HONOLULU AUTHORITY for RAPID TRANSPORTATION

Value Engineering Cost Proposal (VECP) Change Order Farrington Highway Station Group Contract (FHSGC)

Pending Contract Change Order No. 00012

CCO replaces seventy-one (71) drilled shaft piles at the Waipahu Transfer Center Station with:

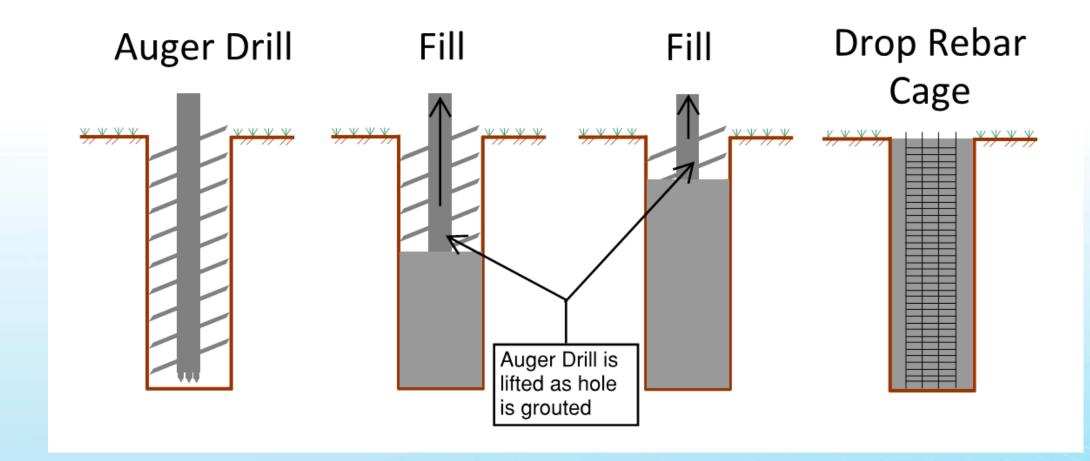
Traditional Drilled Shaft

Auger Cast Grouted Pile

- Time savings
 - ► 2-3 ACGP per day
 - ≥2-3 days per drilled shaft.
- Cost savings Faster installation and reduced equipment results in significant cost reduction
- Reduced risk Shaft is supported by auger that is withdrawn as concrete is poured results in less caving and easier management of groundwater.

- Sixty-seven (67) ACGP
- Four (4) 72" drilled shafts to support the pedestrian bridge
